HUDSON LOGISTICS CENTER

SP #12-22 & CU #07-22

Staff Report #2

**Re: Town of Hudson Planning Board Review
Hudson Logistics Center Amended Site Plan, Lowell Road
Response to Fuss & O'Neill Letter dated September 28, 2022
Langan Project No.: 151010102**

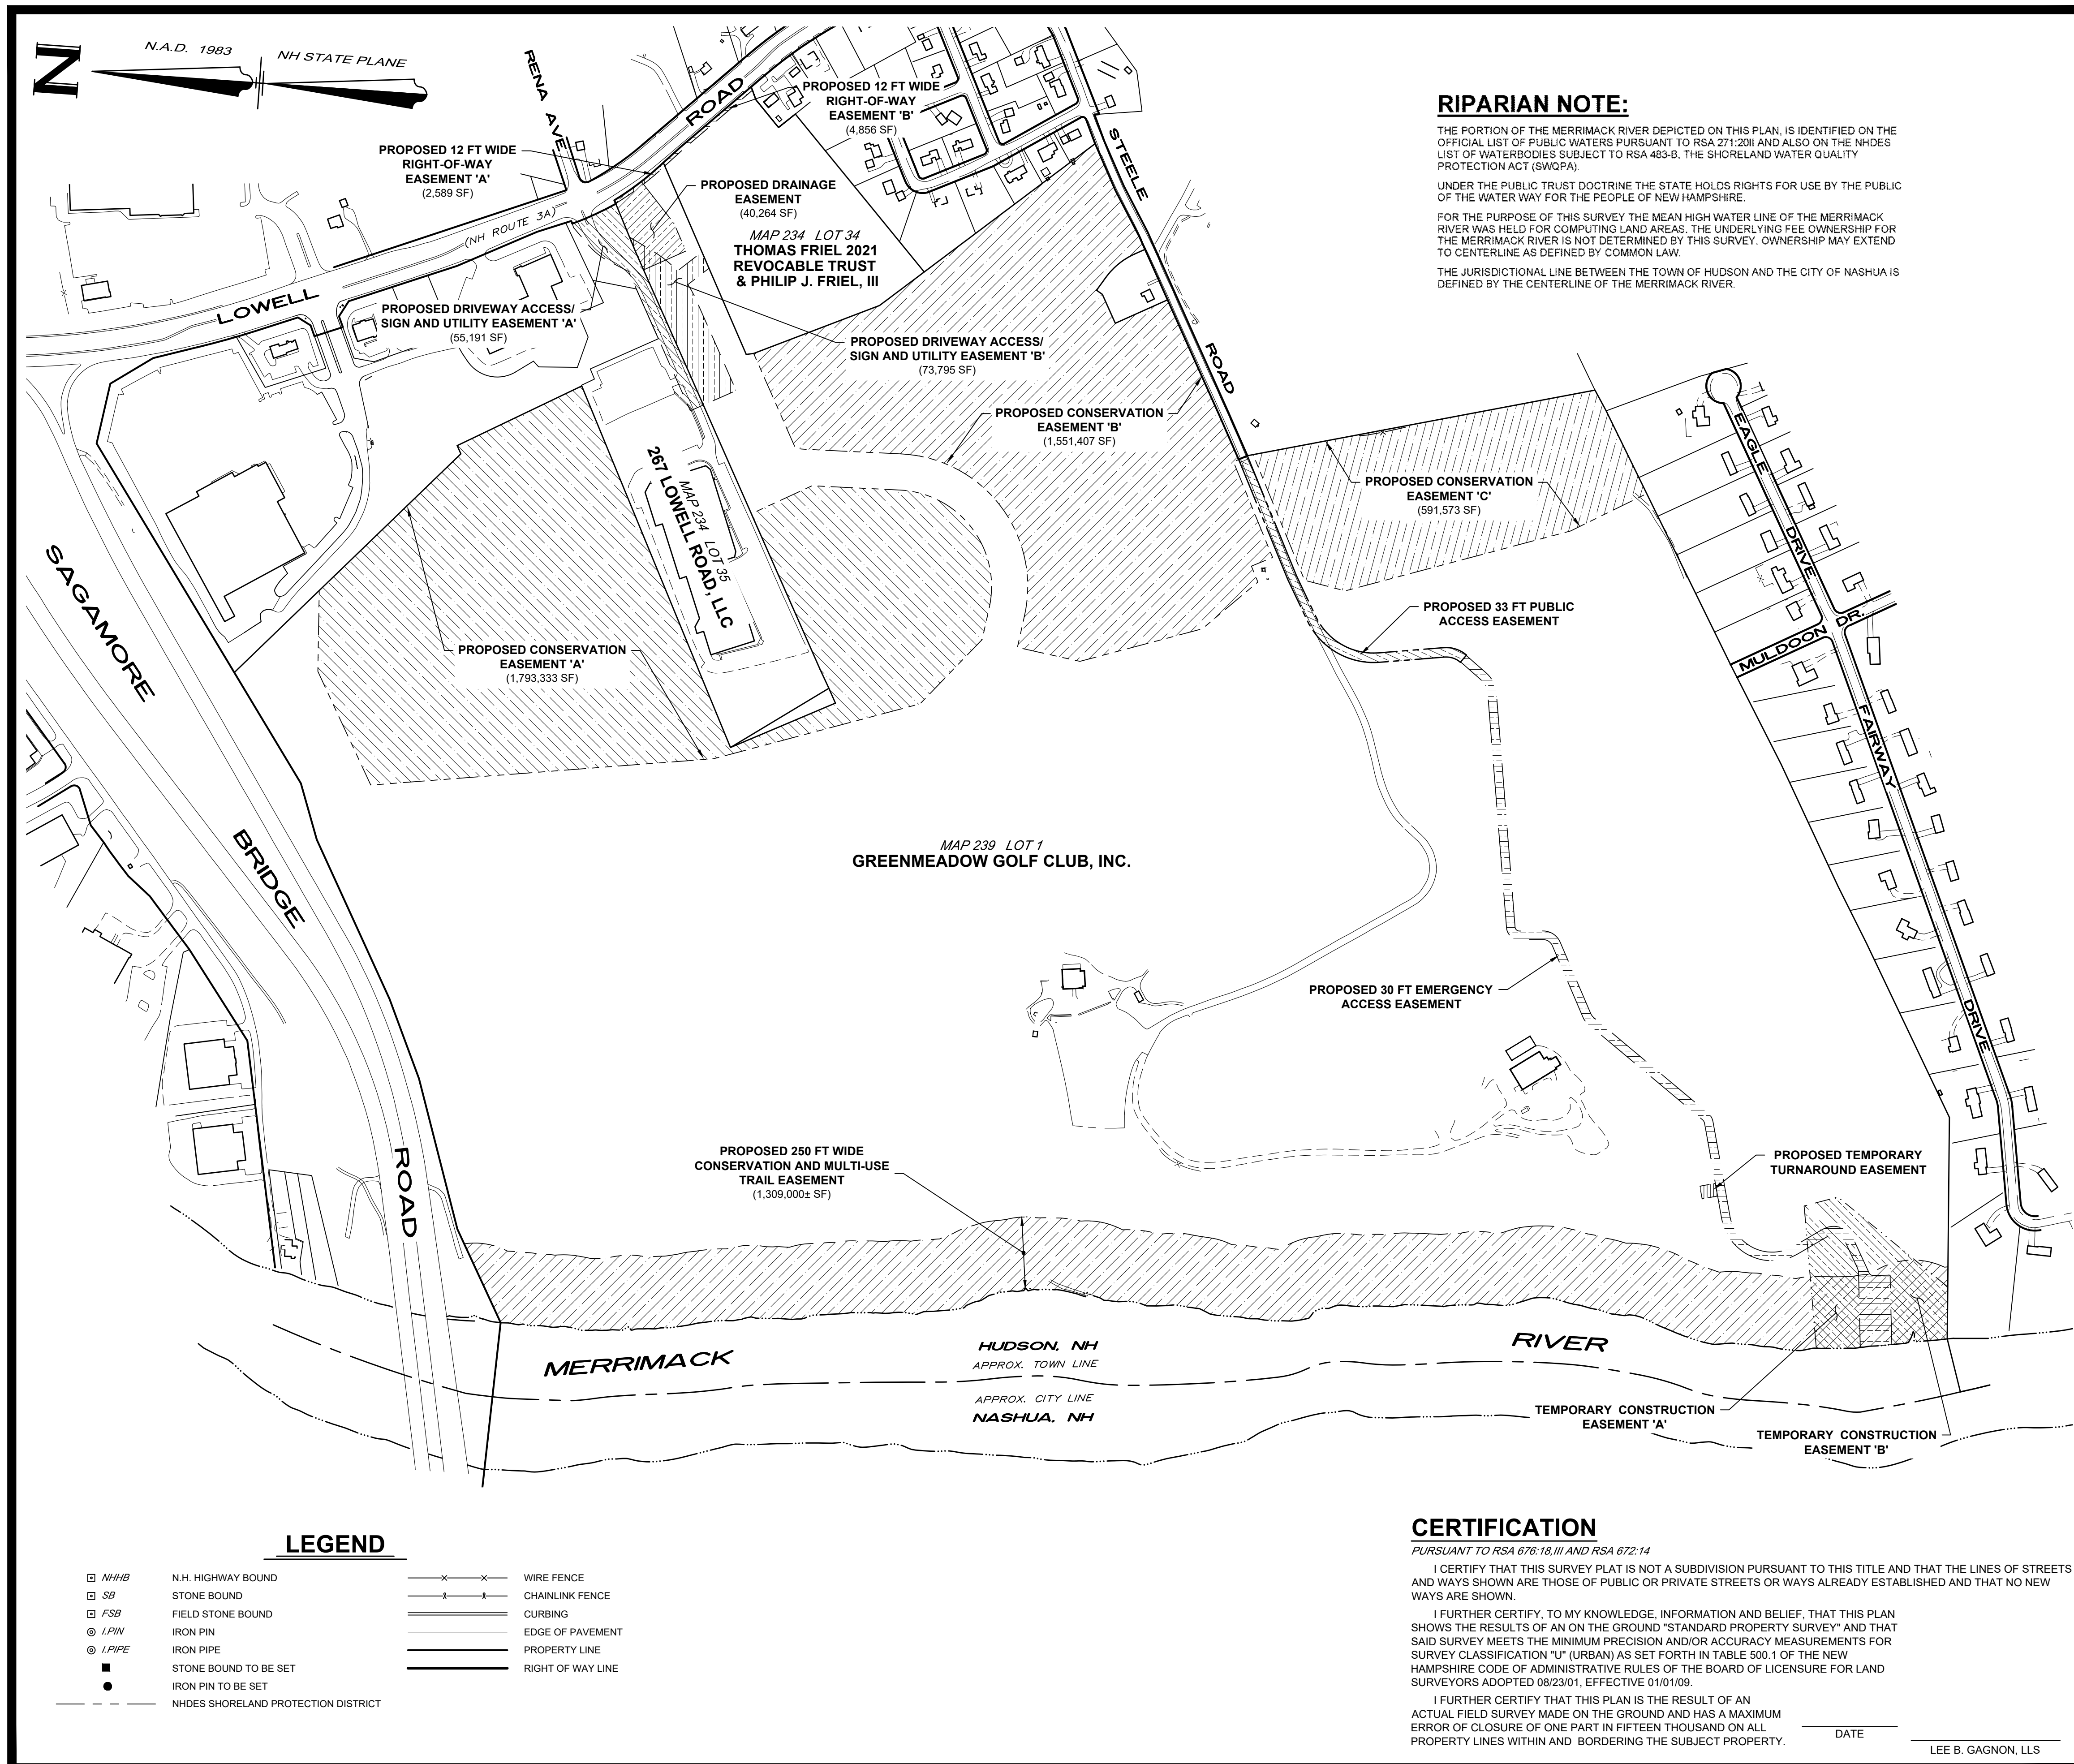
- b. The applicant should add the missing parking space lines on Drawing CS117.

COMMENT RESPONSE: Sheet CS117 will be revised.

Project No.	Figure
151010101	FIG.1
Date	
10/05/2022	
Drawn By	
Checked By	
KIH	
TDO

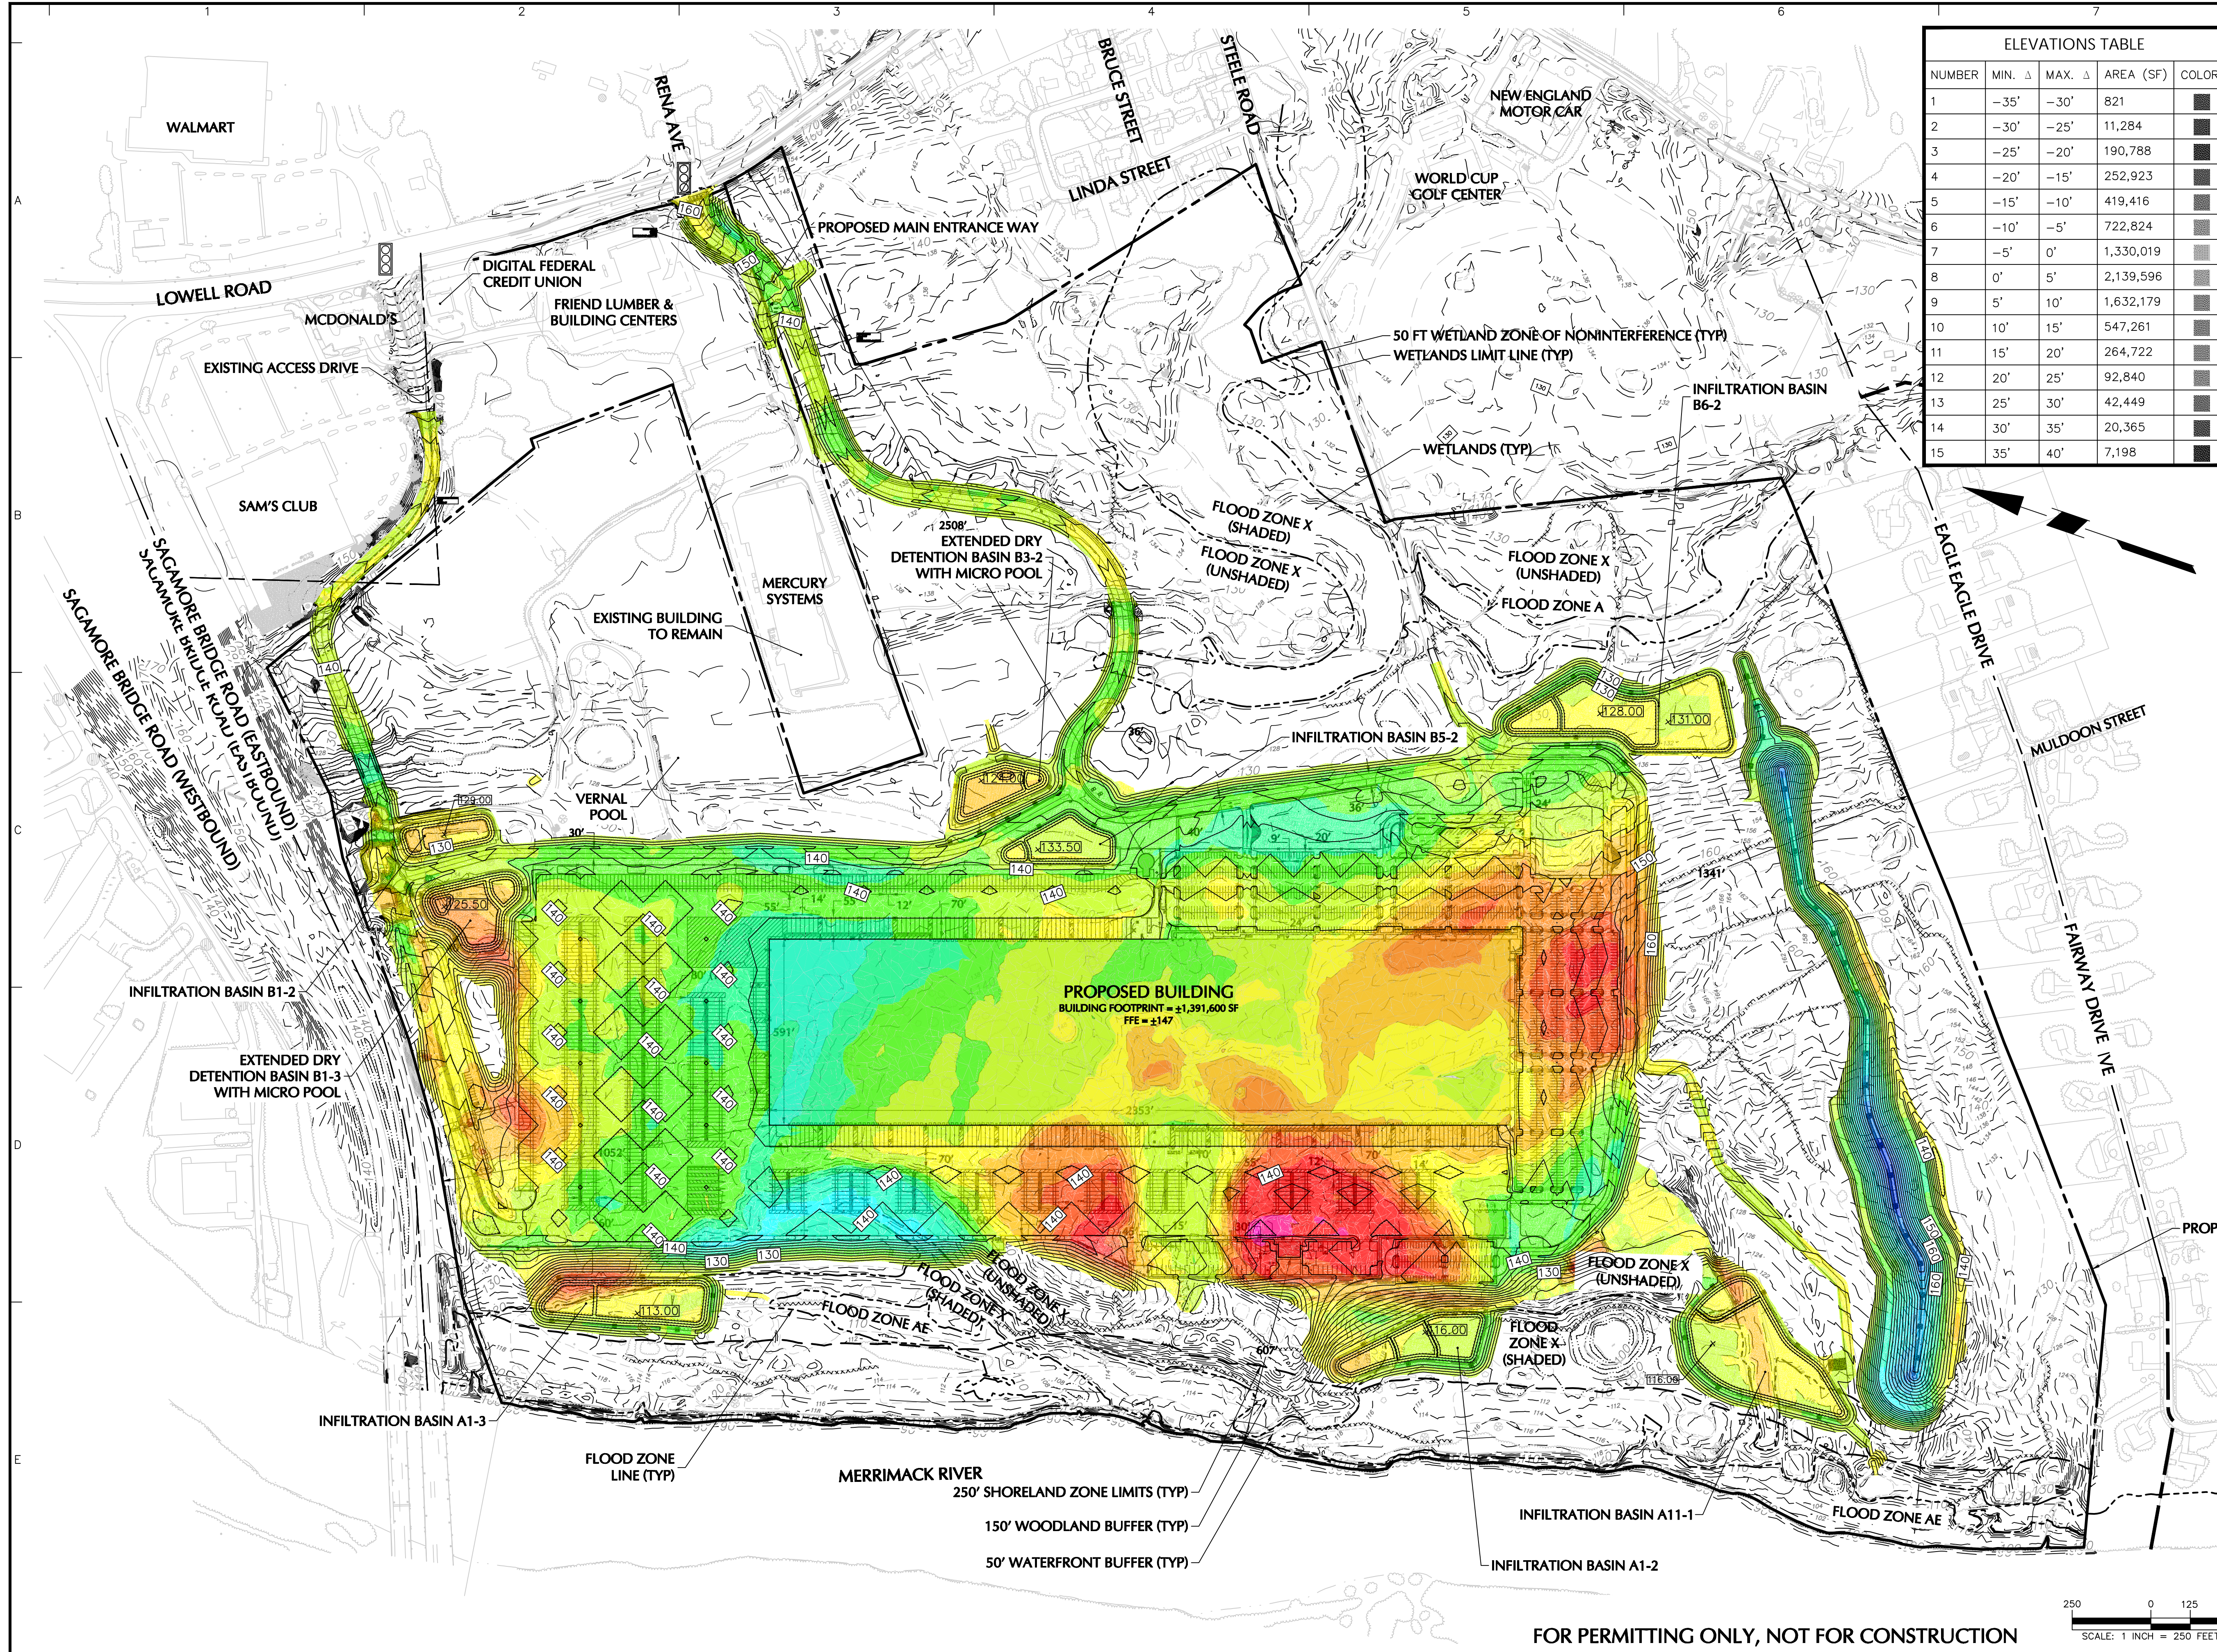
- l. HR 290-7.A.7. It would be beneficial for the applicant to provide a color-coded cut and fill volume plan and report with a maximum of 5 foot increments. This simple visual tool will

allow the Planning Board, Town Agents, and general public to grasp the amount of earthwork disturbance proposed for the project.

COMMENT RESPONSE: Please refer to the attached Fig. 1 "Cut Fill Plan" for proposed cut and fill areas of the project.
